Subject: Request for Amendment and Renewal of Certificate of Compliance,
Docket No. 71-6744

ATTACHMENT

PPI DRAWING 32216, SHIELD - TRANSPORTATION CASK

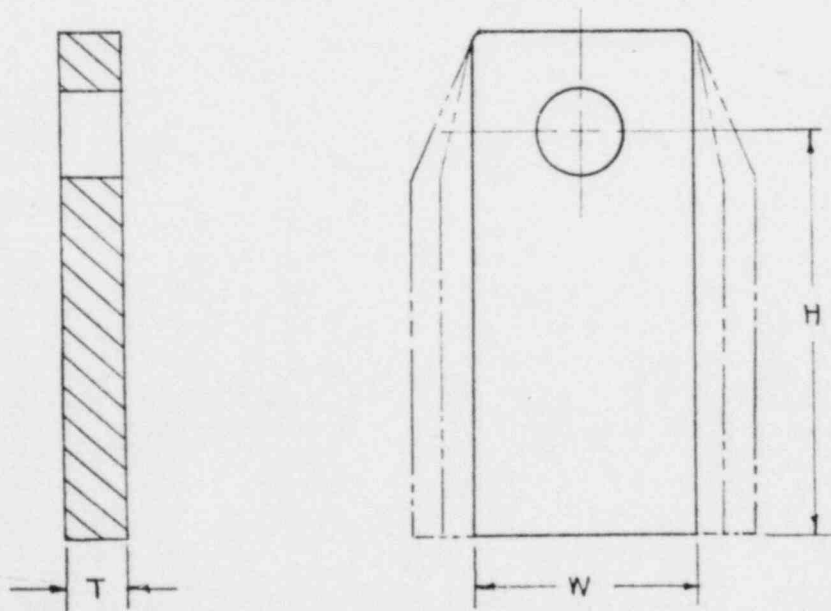
The primary lifting lug design has been improved to provide greater structural margins than were initially reported. This has been accomplished in three ways.

1. The thickness of the lifting lugs have been increased for both the -1 and -2 casks. Therefore, these two lugs are stronger in tension, bearing and double shear at the lifting eye.
2. The length of all lifting lugs have been increased. This change provides greater weld length. This results in lowering the shear stress in the welds.
3. The width of lifting lug was increased for the -3 and -4 casks.

<u>Cask Assembly</u>		<u>-1</u>	<u>-2</u>	<u>-3</u>	<u>-4</u>
Revised Design	T	1.25	1.25	1.25	1.25
	W*	4.0	4.0	6.0	8.0
	H	11.5	12	13	14
Original Design	T	.75	1.0	1.25	1.25
	W	4.0	4.0	4.0	4.0
	H	10.5	11	12	13

In addition to modifying the lifting lugs, the updated design now includes the addition of an annular ring around the periphery of the cask. The ring in each case is adjacent to the upper closure of each cask and is integral with the lifting lugs. This design change eliminates the local loads into the cask outer shell from the lifting loads. Now these loads are effectively spread out resulting in significantly lower shear stresses in the shell. Ring cross sections for the -1, -2, -3 and -4 casks are 2-1/2 x 3/4, 3 x 1, 3-1/2 x 1-1/4 and 4 x 1-1/4, respectively. Drain holes were also incorporated at three locations through the ring.

Lower Corner Design

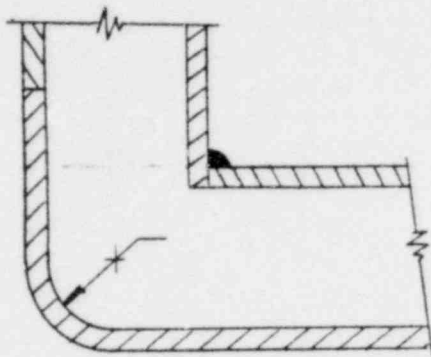
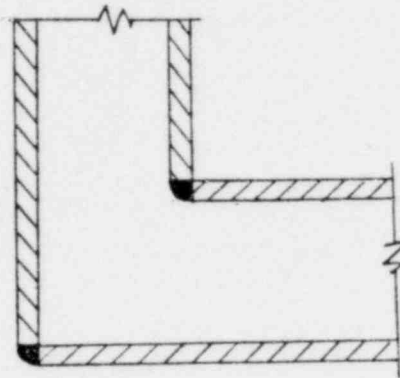
The interface between the cylindrical wall and the lower closure of the casks was initially rounded at the edge as shown in the accompanying sketch. Revision D of Drawing 32216 provided an optional design whereby the edge was squared off. Revision J selected the optional design as the primary design. It is assumed that the reason for the change was based upon eliminating the need for forming of the closure shell. The later design neither adds nor detracts from the capability of the cask to withstand any significant loading environment.
